**CITY OF FRANKLIN**  
**REPORT TO THE PLAN COMMISSION**

Meeting of December 7, 2017

**Unified Development Ordinance Text Amendment and Temporary Use**

**OVERALL LANDSCAPE PLAN**

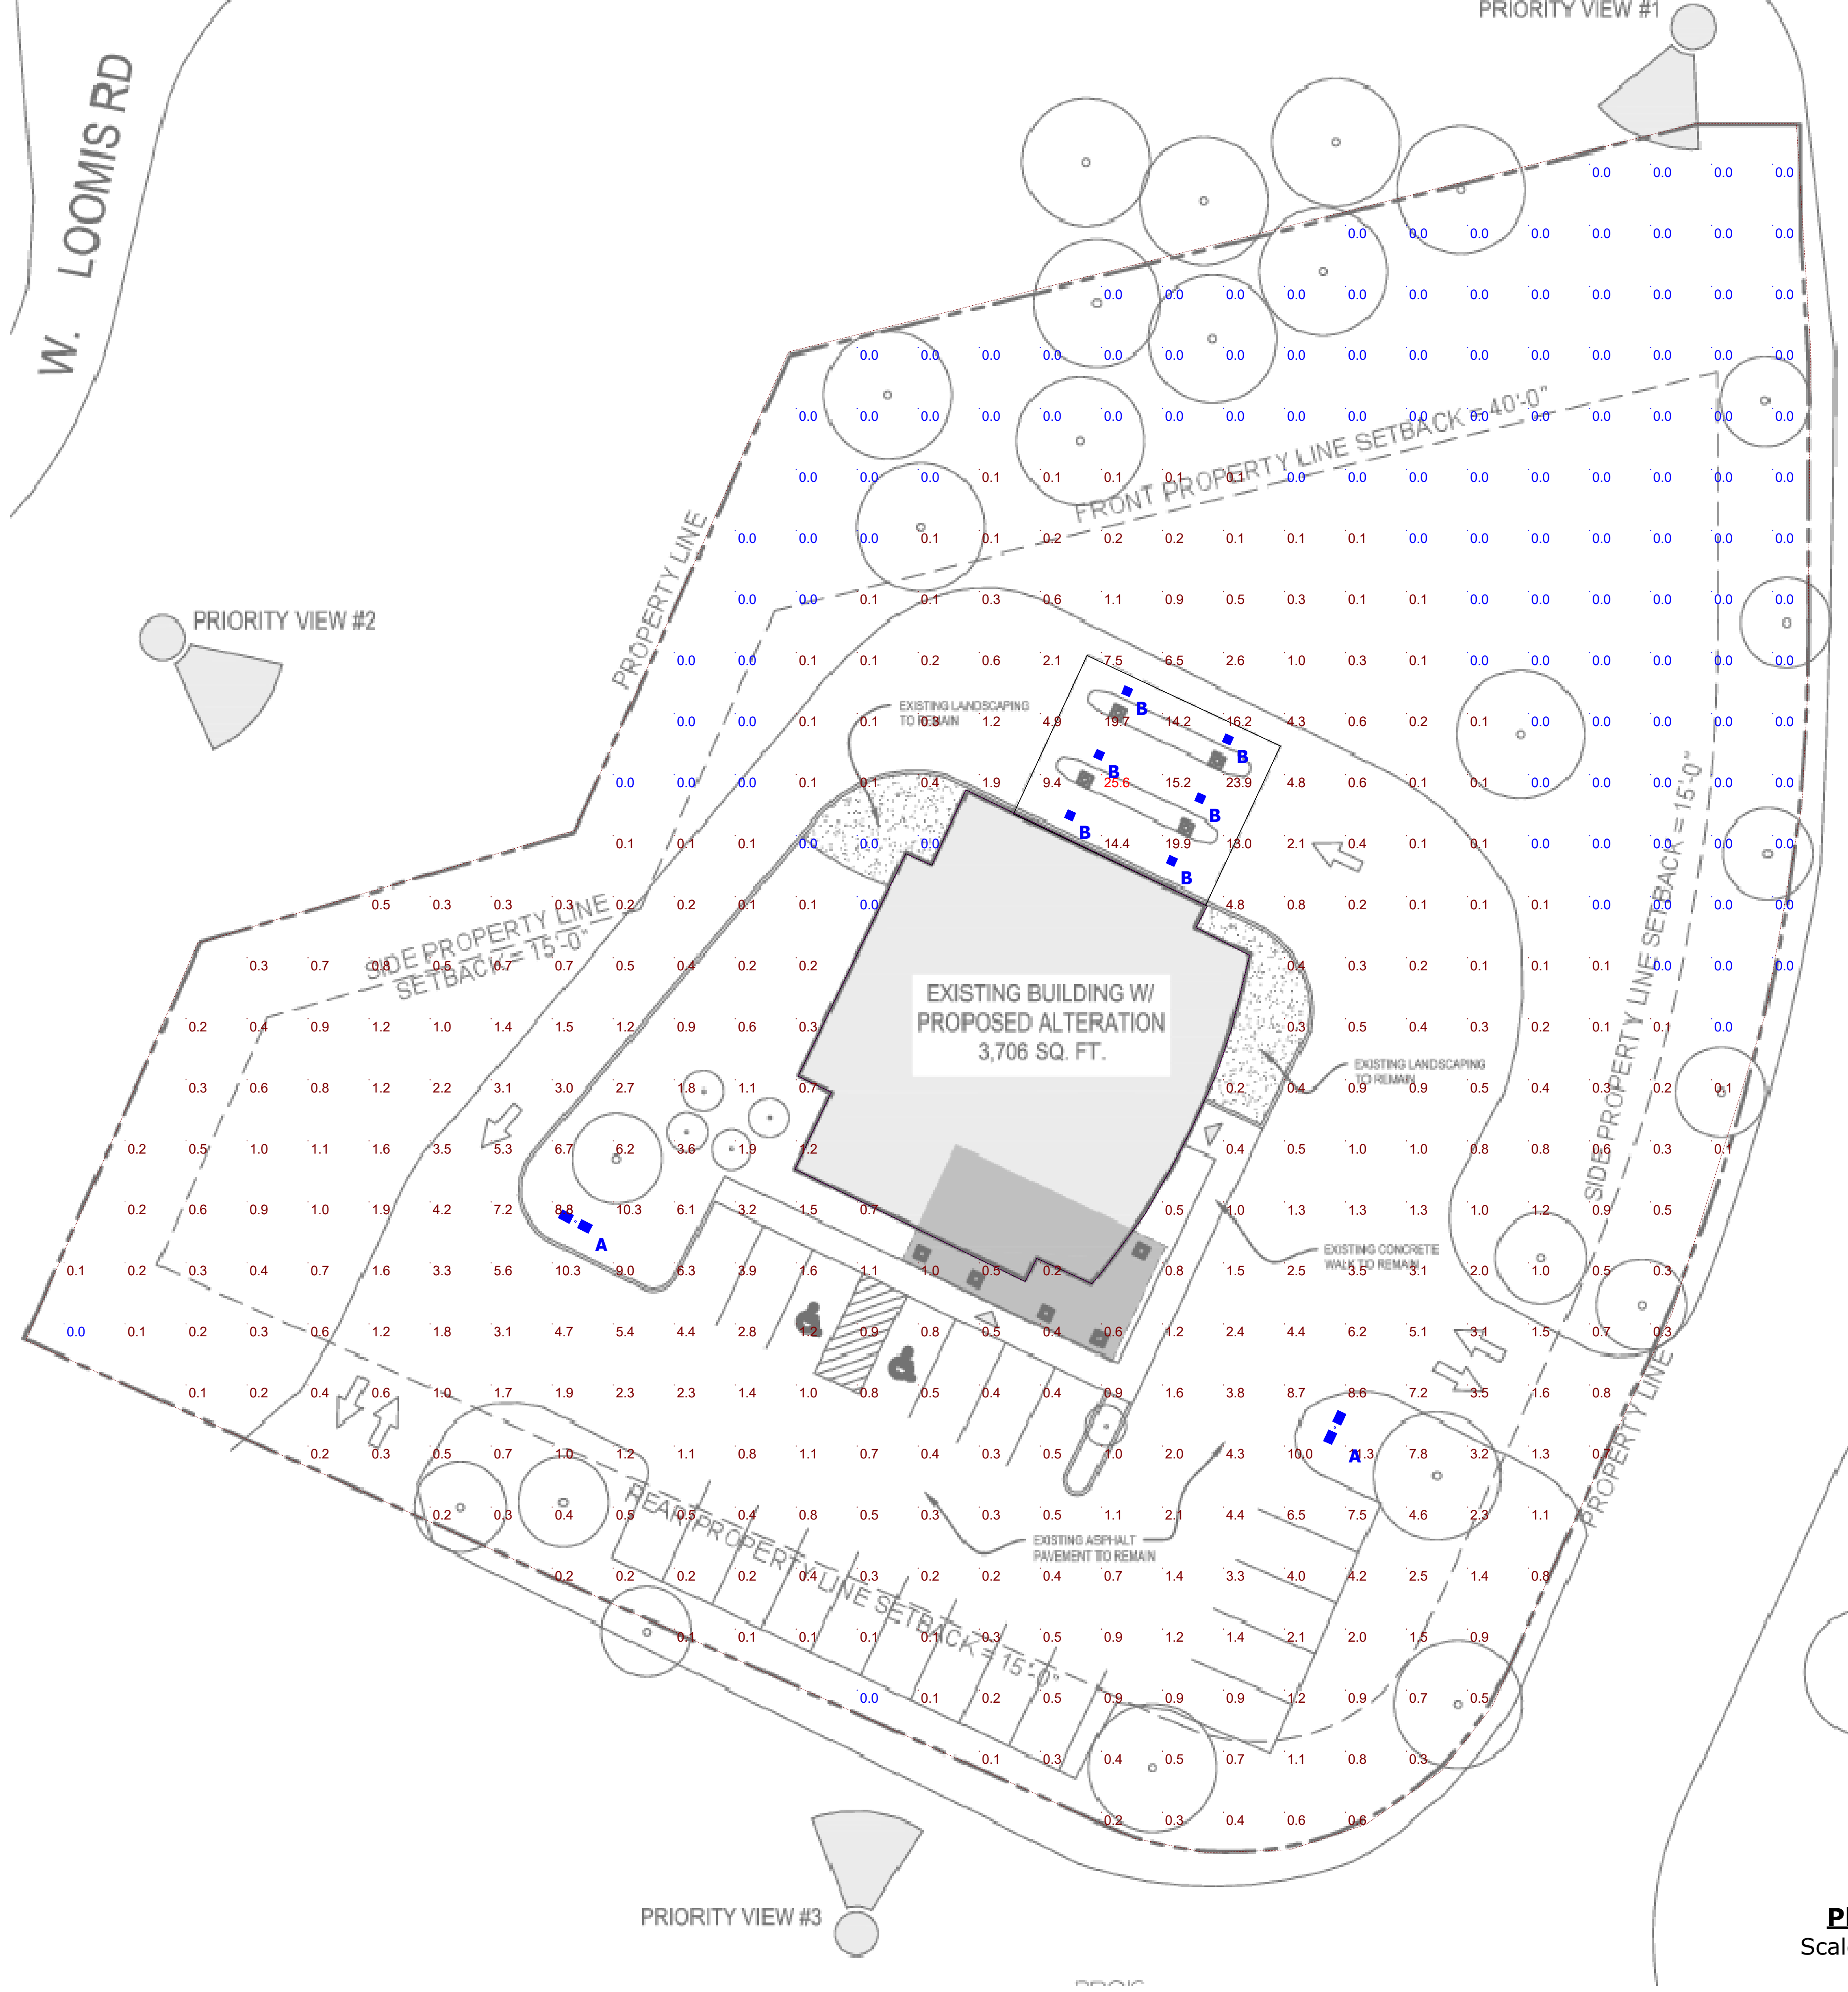
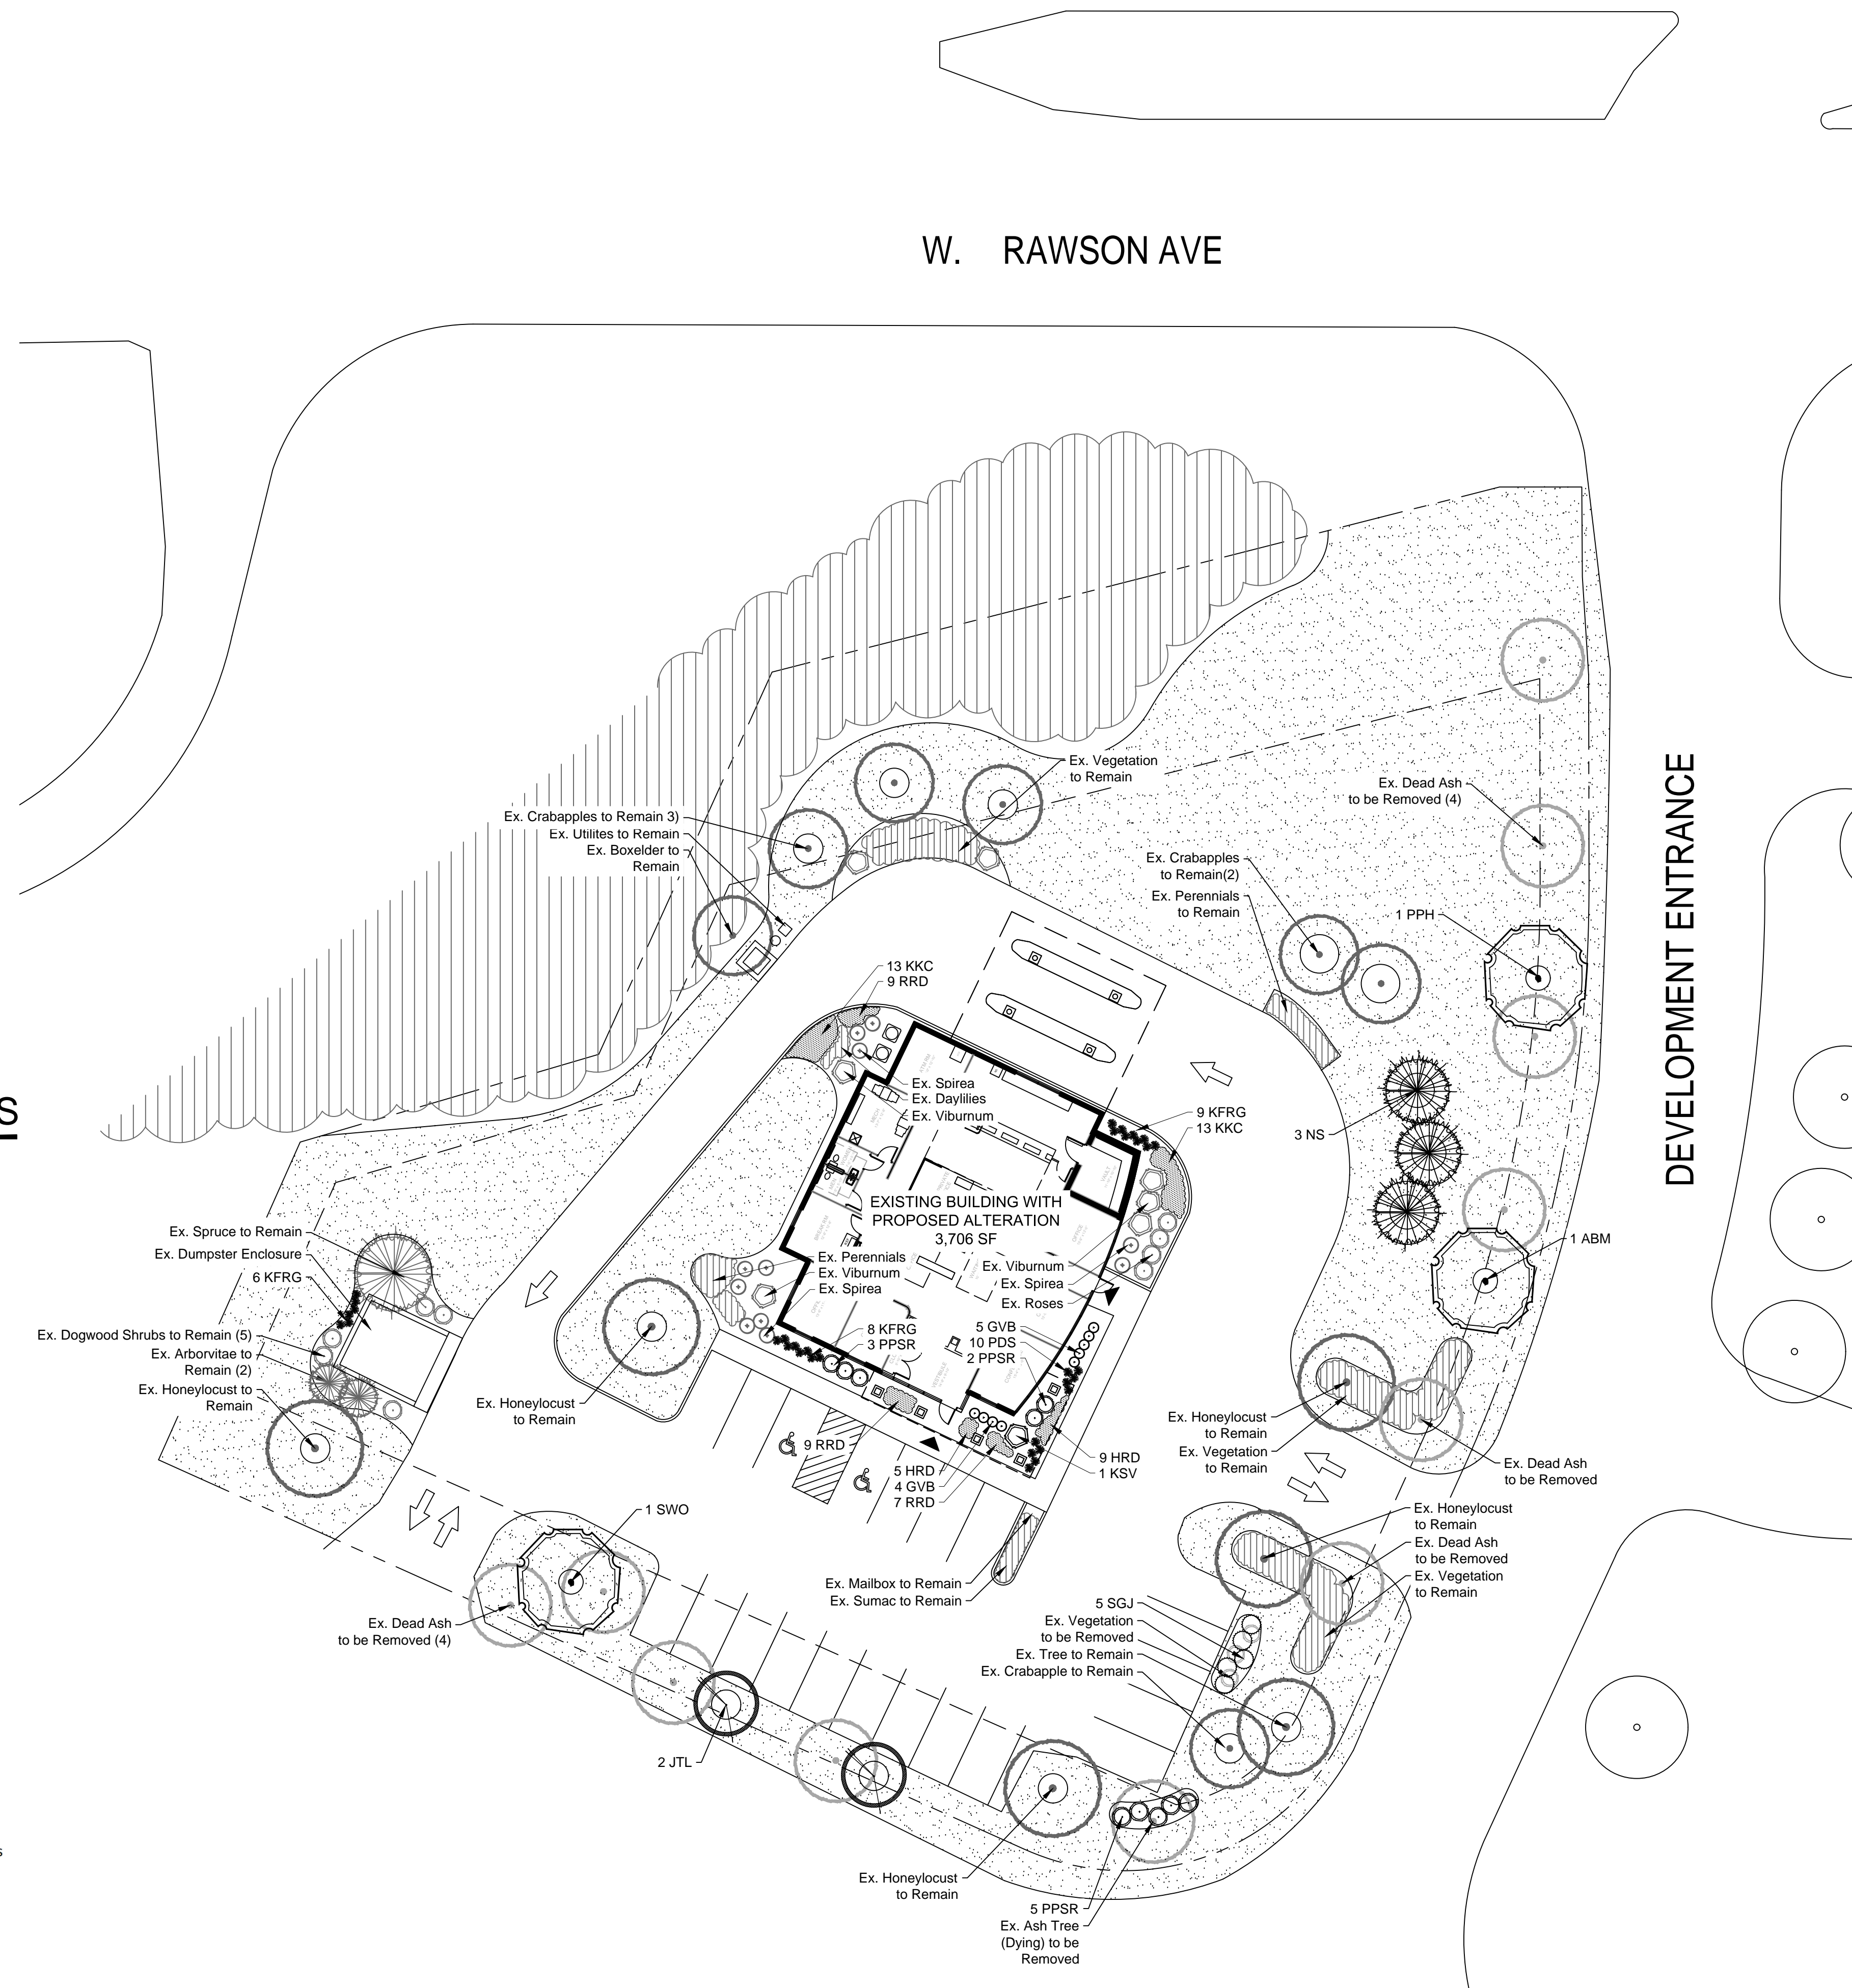
The applicant has submitted a Landscape Plan partially addressing the current UDO landscaping standards. However, it should also be noted that the 2002 Special Use approval for Anchor Bank included a landscape plan that provided slightly more landscaping than is required by the UDO standards. Furthermore, it can be noted that the original PDD No. 16 approval included a landscape plan for all of the entrance drives and parking lot perimeters, which partially extends unto the subject parcel. In regard to the portion of this landscaping on the subject parcel (comprising 15 trees), some have subsequently died, are dying, or are no longer present.

*Staff recommends that the applicant shall prepare a revised Landscape Plan meeting all UDO standards and re-establishing the PDD No. 16 approved landscaping as it applies to the subject parcel, for Department of City Development review and approval prior to issuance of a Building Permit, and that all required landscaping shall be installed prior to issuance of an Occupancy Permit.*

6. Pursuant to Sections 15-7.0102H. and 15-7.0103R., please provide a Landscape Plan. – Please see attached Landscaping Plan for reference.
  - a. Please note that staff does not object to re-establishment of the previously approved landscape plan for the Anchor Bank development dated 7-8-02, subject to replacement of the Ash Trees with some other native trees, verification that all originally proposed landscaping still exists and is healthy, and with additional landscaping added based upon any parking stalls added (per the standards set forth in Section 15-5.0300 of the UDO).
